SUFFOLK COUNTY'S APPLICATION FOR ISSUANCE OF SUBPOENAS

Transamerica Delaval DSR-48 Diesel Engine/Generator
for Long Island Lighting Company Shoreham Plant
Report on Crankshaft Torsional Stresses.

Subject: Report on Crankshaft Torsional Stresses
Transamerica Delaval Model DSR-48
Serial No. 74010/12
for Long Island Lighting Company

Figure 3-1. Goodman diagram for replacement crankshafts.

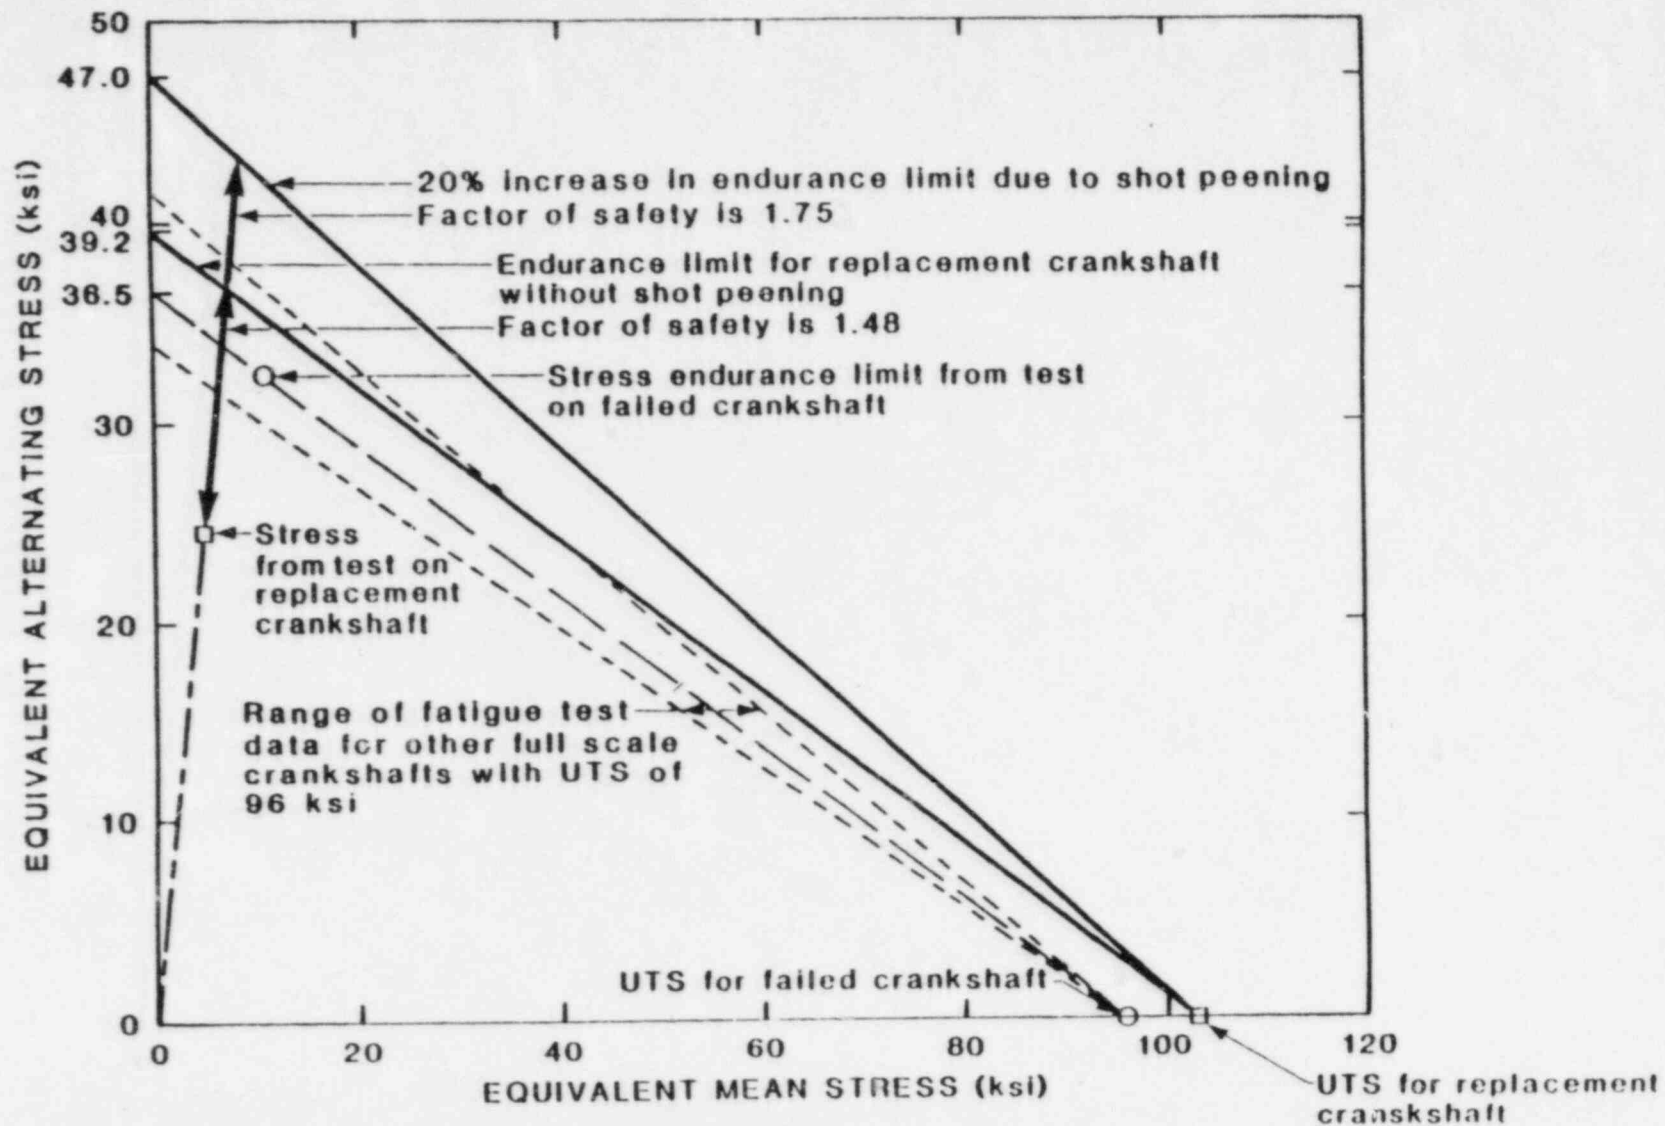
We note from the submitted report that the torsional vibration stress in the crankshaft for the first mode $5\frac{1}{2}$ order critical speed (422 RPM) was expected to approach or exceed that permitted by the Rules for the submitted crankshaft material.

We further note from the submitted report that tests were conducted to determine the actual stresses in the crankshaft, and that these tests indicated a substantial margin of safety against fatigue failure due to torsional vibration.

Based on the submitted test data, and on submitted service experience with similar engines having similar torsional critical speed arrangements, we advise that we would have no objection to the submitted torsional critical speed arrangement for use on diesel generator sets on an ocean going vessel, insofar as our classification requirements for marine service are concerned.
